MIL-T-9560B(USAF)
AMENDMENT 2
21 DECEMBER 1983
SUPERSEDING
AMENDMENT 1
1 May 1969

MILITARY SPECIFICATION

TEST SET, RADIO FREQUENCY POWER AN/USM-68 ( )

FIGURE 1. Bolometer element common design.

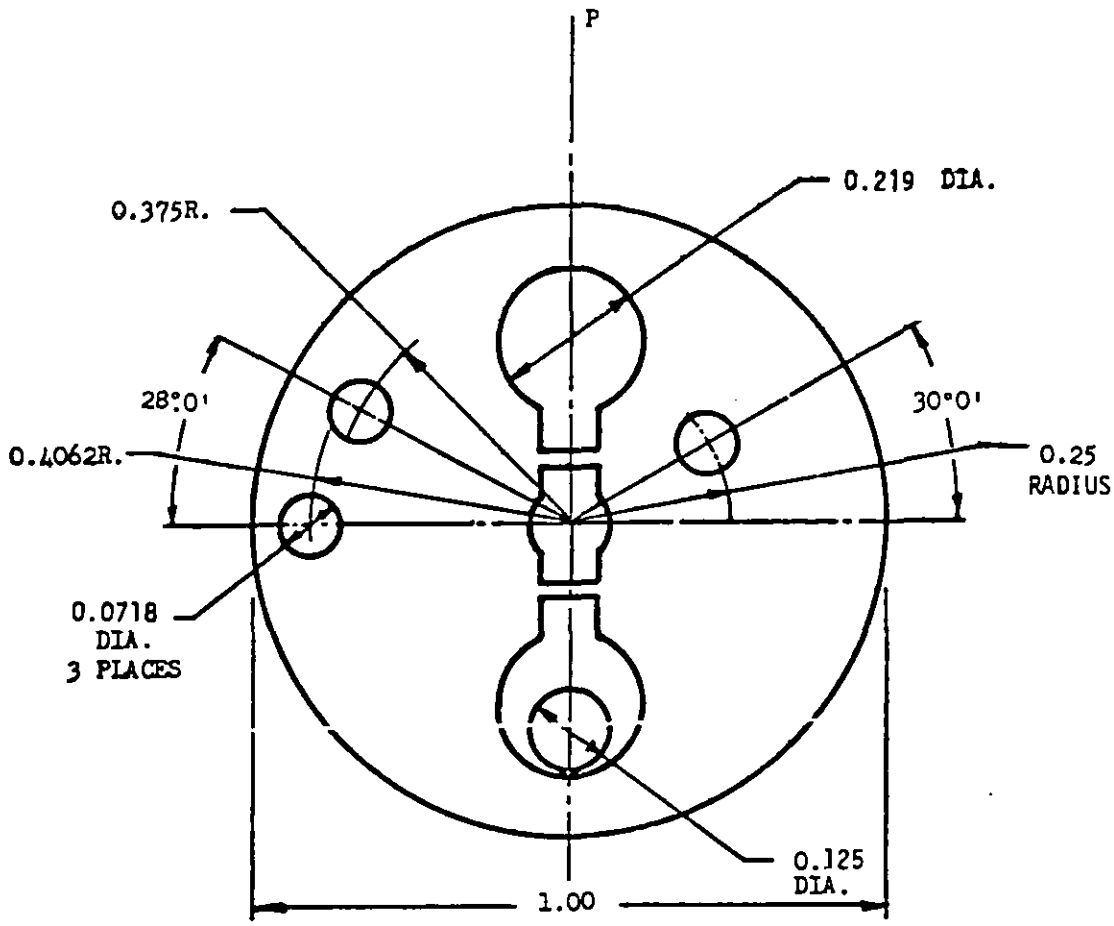
Figure 1: Delete and substitute new Figure 1.
